RESPONSE TO PLANNING FEEDBACK

Client: Hopwood Hall College
Project: Conversion of Former Chapel
Reference: 20765-HCO-TC030
Date: August | 2024

**HOPWOOD HALL COLLEGE, MIDDLETON CAMPUS, ROCHDALE ROAD, MIDDLETON, M24 6XH
Application Nos 24/00548/LBC & 24/00547/FUL**

PROPOSED PLAN

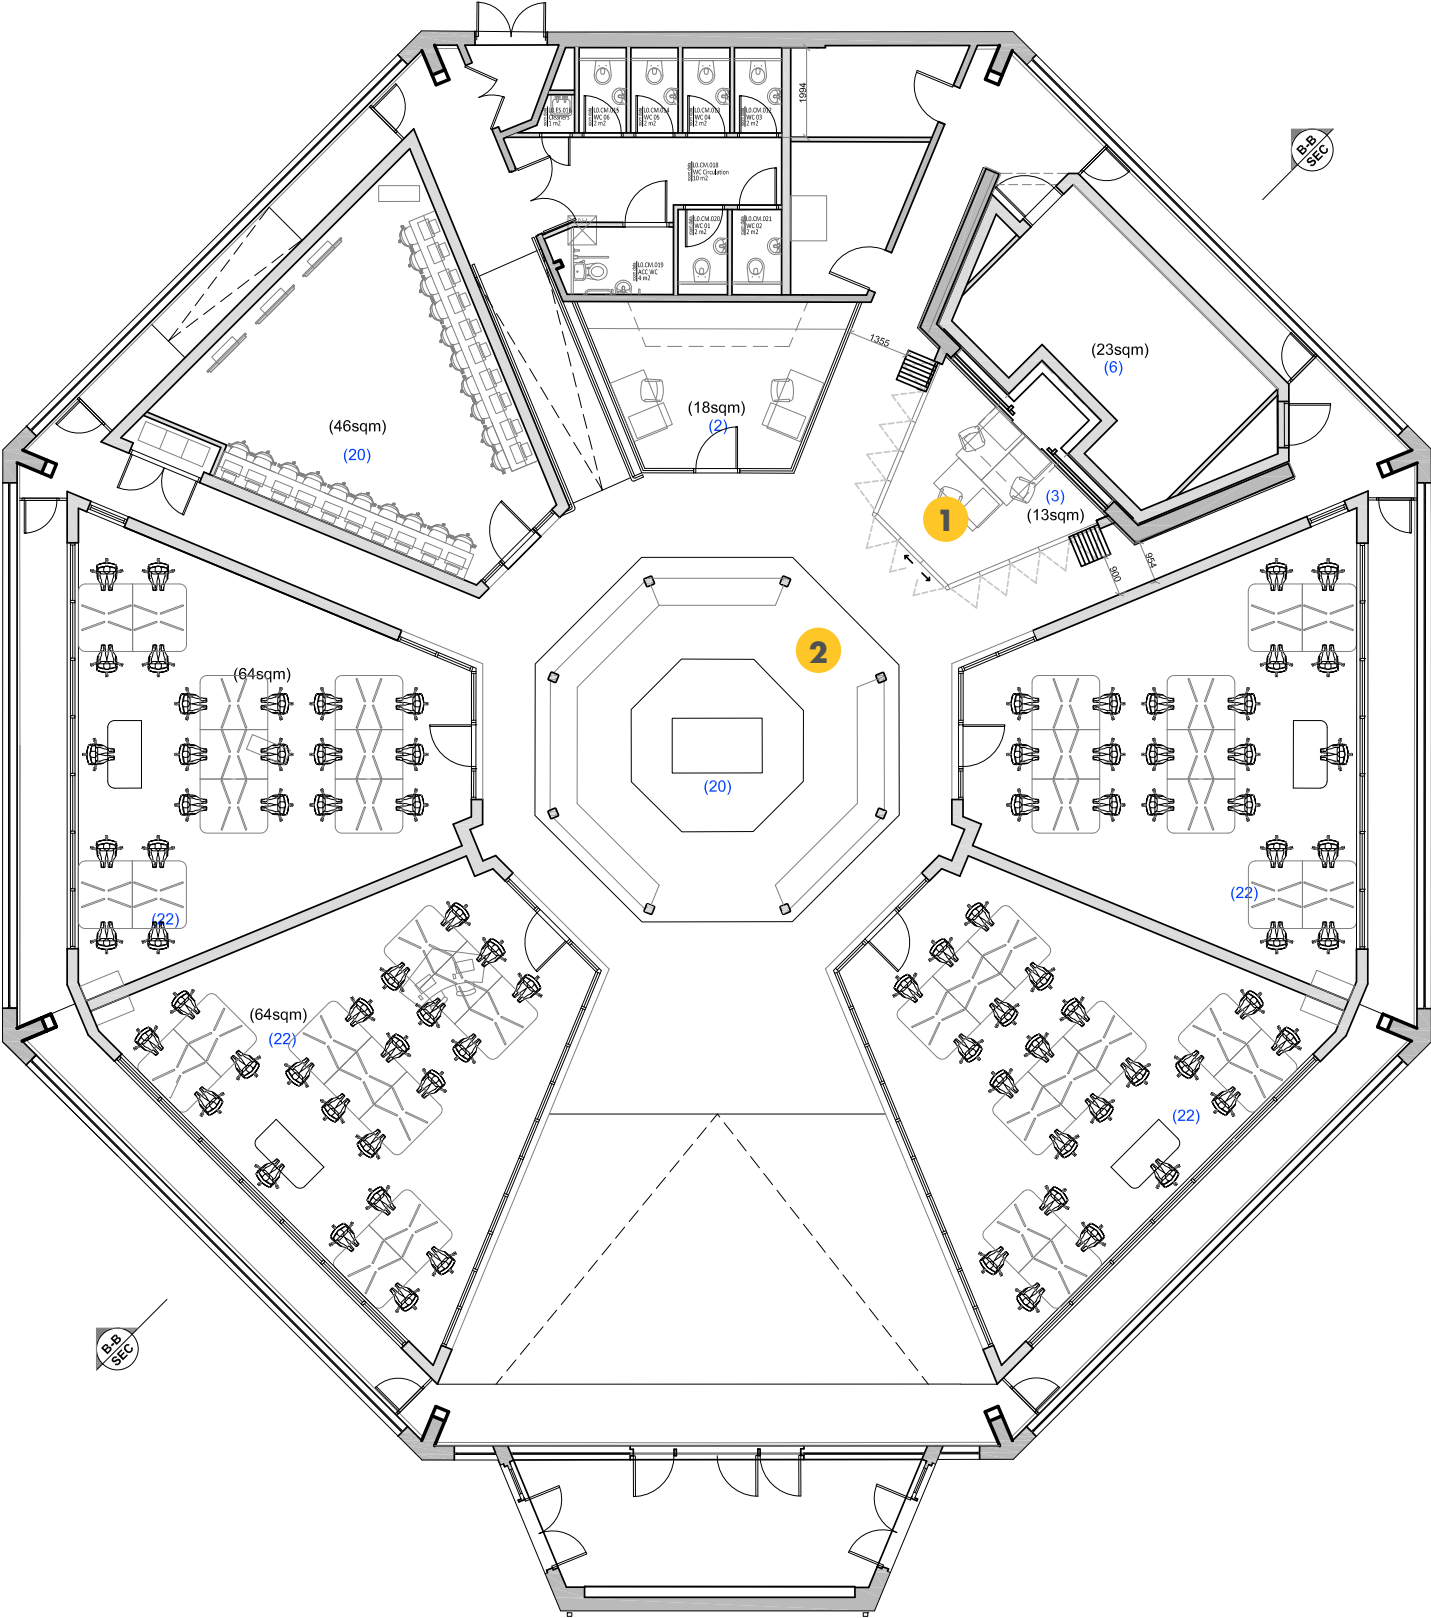
We do however have concerns about proposals to enclose the Blessed Sacrament chapel to create an immersive VR space and staff office. We feel that this chapel should be left unenclosed and remain

- 1 Bi-folding doors to Office
- 2 Sanctuary area amended

Site Plan Illustrating Existing developed area around the Chapel

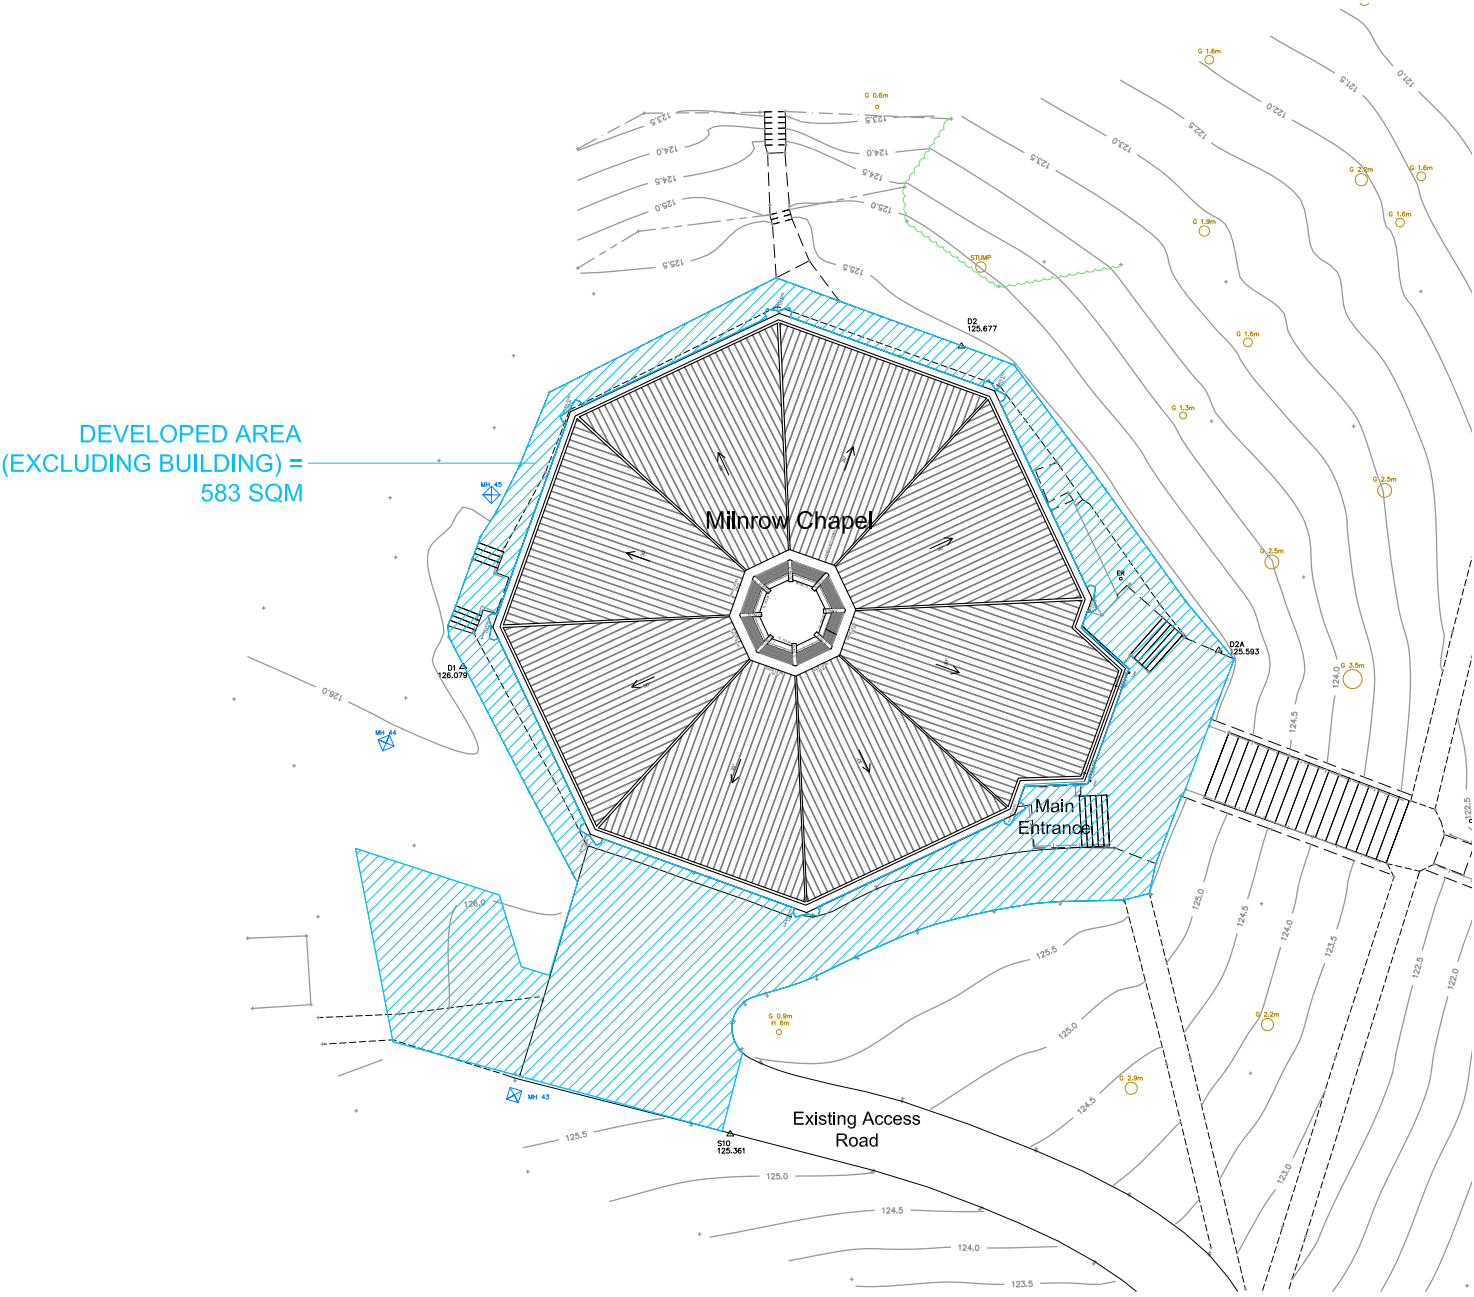
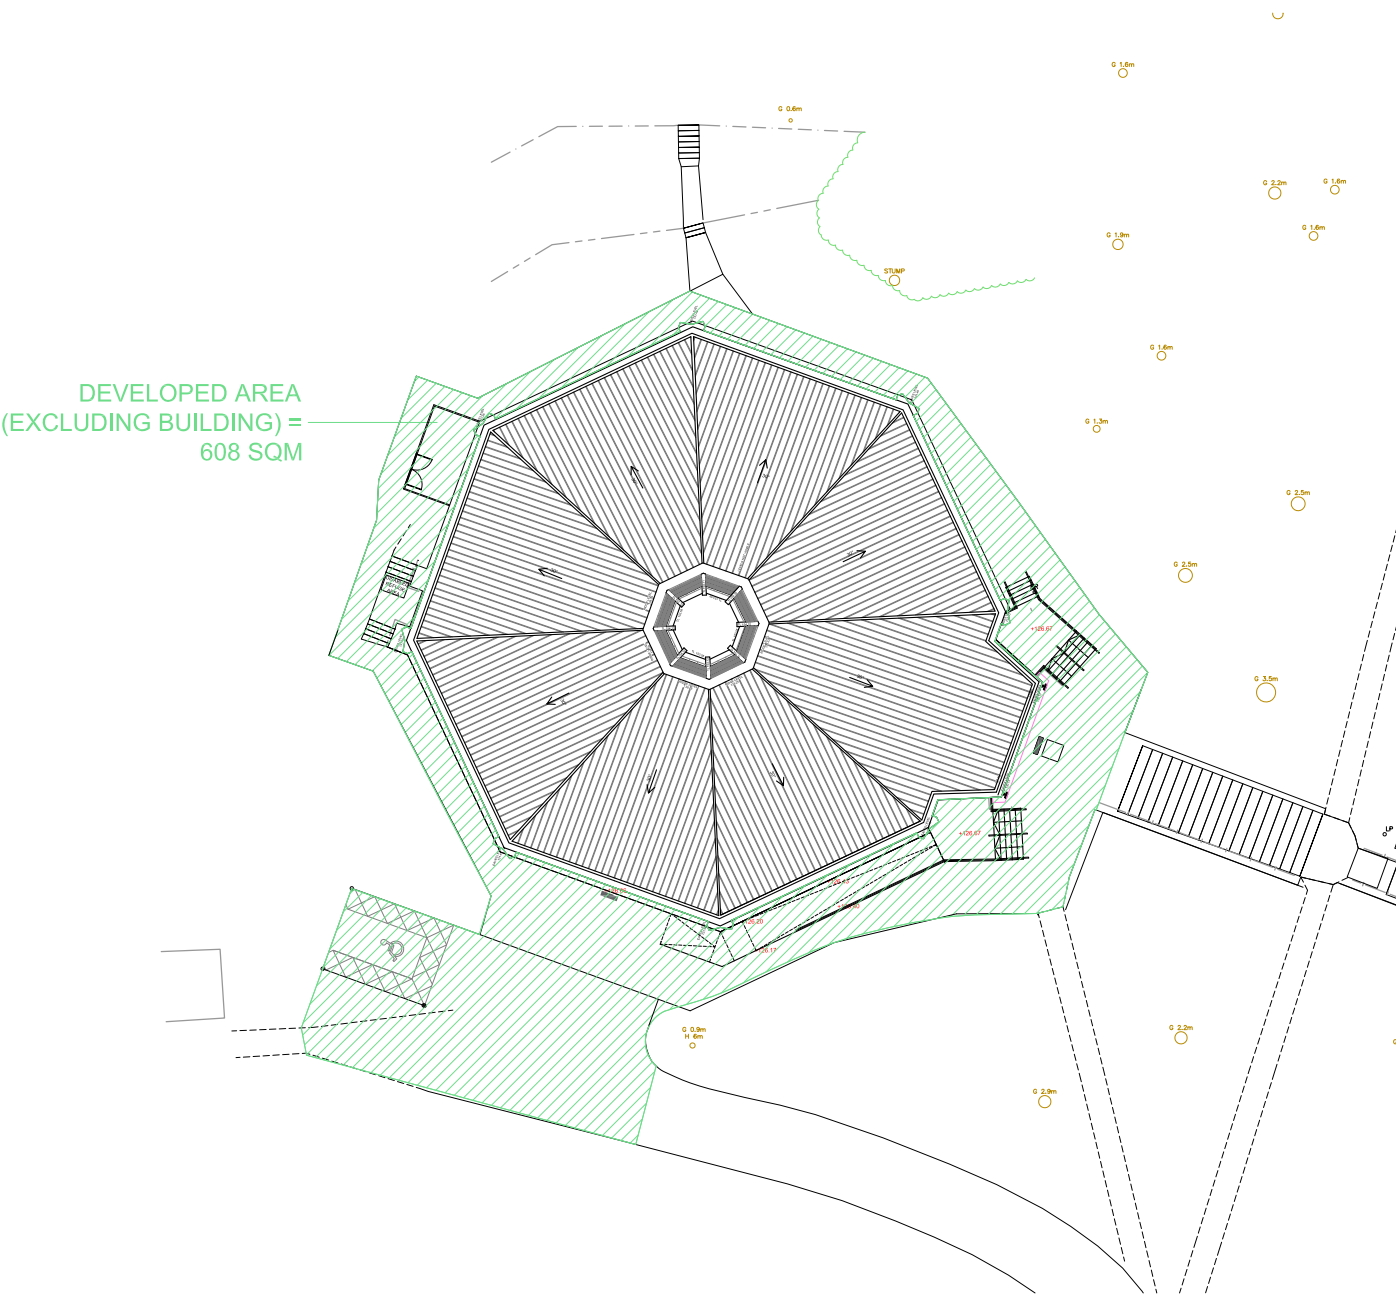
The development appears to be primarily refurbishment and conversion of the existing building and refurbishment of the hard landscaping with only a minor loss of vegetated habitats being permanent. (eg disabled parking bay). It is however unclear from the proposals whether the refurbished hard landscaping ie access ways will be of the same width. Therefore, whilst I note the applicant has stated the development is exempt from mandatory BNG under the de minimis exemption, from the information supplied this is not 100% clear as some habitat loss is occurring.

I therefore recommend that prior to determination, more detailed information on the habitats present before and after the development is provided including accurate measurements of these habitats. If more than 25sqm of vegetated habitat will be permanently changed, a defra metric should be provided.

Area of existing developed area around the Chapel = 583sqm.

Area of proposed developed area around the Chapel = 608sqm.

The amount of habitat to be permanently changed is therefore calculated as 25sqm.
